## Initial Product/Process Change Notification

Document #: IPCN24698X

| <b>Title of Change:</b>                          | Lead Frame Vendor and Design change for QFN15 Products Assembled in UTAC (UTL) , Bangkok, Thailand.  |

## Current design CWTC supplier

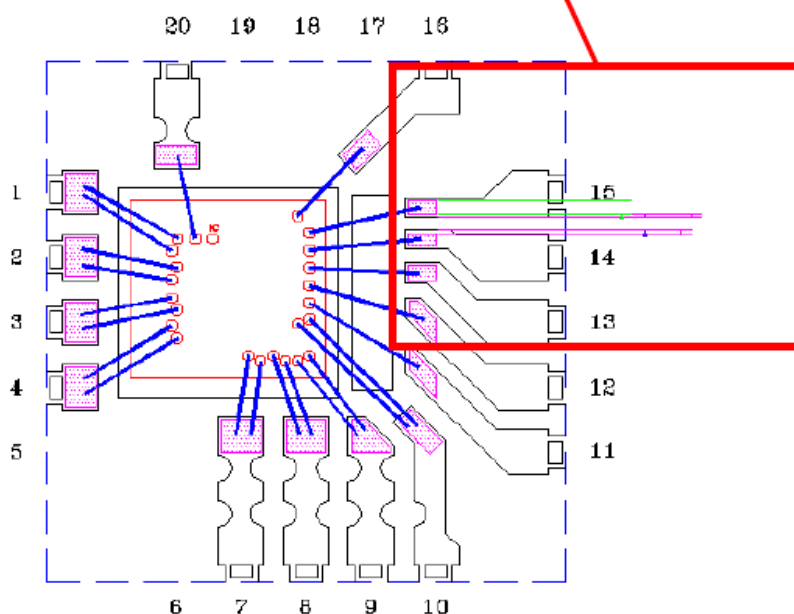
This is an IPCN to notify customers that onsemi has begun qualification of a new vendor for the leadframe in the QFN-15 package assembled at the UTAC, Bangsamak Thailand location for the products listed in this announcement. The previous vendor has discontinued their leadframe product. As a result, the following changes will occur:

|           | Before Change Description                                     | After Change Description  |
|-----------|---|---|
| LeadFrame | Lead frame vendor CWTC with 0.30-1.2 microinch bottom plating | Lead frame vendor Rokko with 1.38 microinch bottom plating and below dimension changes. |
